TO:	ALL BIDDERS	COMPANY:	N/A
FROM:	I.B. STOREY INC.		
SUBJECT:	24-021-ADDENDUM #2		
DATE:	12-DEC-24

The following addendum #2 is being provided for 24-021 Hamilton Detailed Specification and Drawings Package v1.0 – Exhibit M: Detailed Specifications,

Figure 2: Pipe Supports Section View. (See A.07 Building/Wall Section)

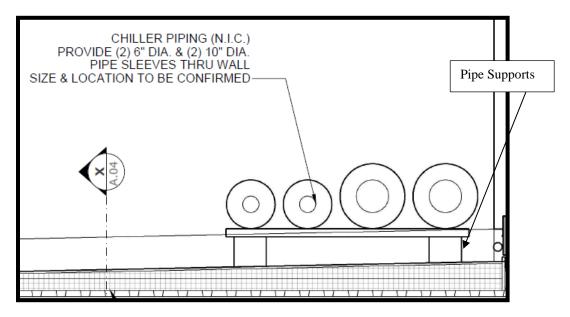
4.8.16 Pipe supports for all dressing room roof piping by others. See Figure 2 for roof pipe supports section view.

Figure 4: Ice Resurfacer Room Excerpt

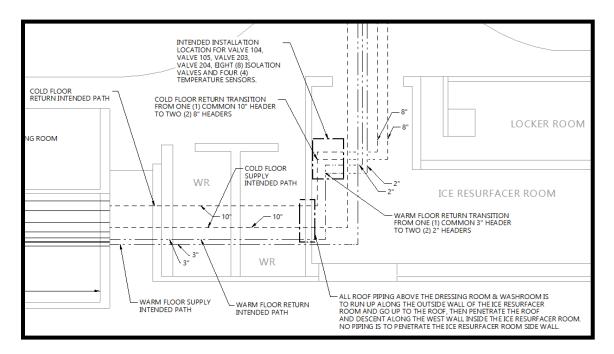
.2 The piping running above the dressing room is to run up to the ice resurfacer room roof, then descent along the west wall inside the ice resurfacer room. No piping is to penetrate the ice resurfacer room side wall. See Figure 4 below.

- 7.2.4.4 Sensors are to be integrated to the automation system in conformity with the drawings package as well as the specifications in Part 3 Automation.
  - .1 Sensor locations are to be integrated to the automation system in conformity with Figure 4 above as well as the specifications in Part 3 Automation
